APPENDIX F

PUBLIC COMMENTS ON THE SUPPLEMENT TO THE DRAFT ENVIRONMENTAL IMPACT STATEMENT AND RESPONSES

Industry has experience injecting CO₂ in quantities comparable to the Gilberton CTL Plant.

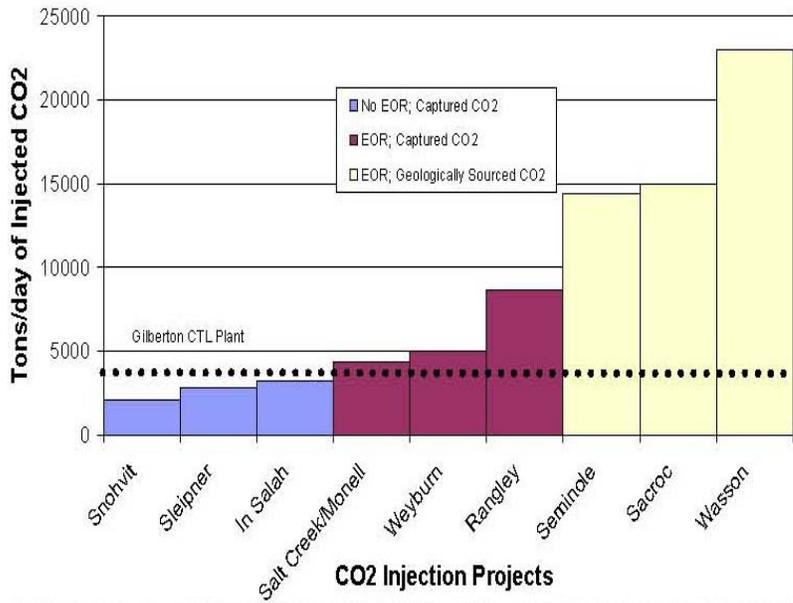
- c. Thousands of CO₂ injection wells are safely and economically operating in over 70 CO₂ EOR projects in the USA and more in other countries. Thirty million tons per year of new CO₂ plus additional quantities of recycled CO₂ is injected in EOR project wells in the USA. Some CO₂ EOR projects inject at rates higher than or near the 3,973 tons per day needed for the Gilberton CTL project. See Figure below for some examples.

- c. Thousands of CO₂ injection wells are safely and economically operating in over 70 CO₂ EOR projects in the USA and more in other countries. Thirty million tons per year of new CO₂ plus additional quantities of recycled CO₂ is injected in EOR project wells in the USA. Some CO₂ EOR projects inject at rates higher than or near the 3,973 tons per day needed for the Gilberton CTL project. See Figure below for some examples.

The comment correctly interprets the meaning of the quoted statement in Section 4.2. The statement is focused on the storage or sequestration technology. While the proposed facilities would produce a segregated CO₂ stream, thus accomplishing the “capture” step, sequestration of this CO₂ stream is not included as part of the proposed project, and therefore, is not a reasonable alternative for DOE to consider.

DOE is aware of the ongoing and planned enhanced-oil-recovery projects described in the comment, all of which take advantage of physical conditions and economic situations favorable for this type of activity. The IPCC Special Report on Carbon Capture and Storage (IPCC 2005) did characterize geologic storage in saline formations or oil and gas fields as “economically feasible under specific conditions,” such as the presence of favorable tax regimes or other incentives.
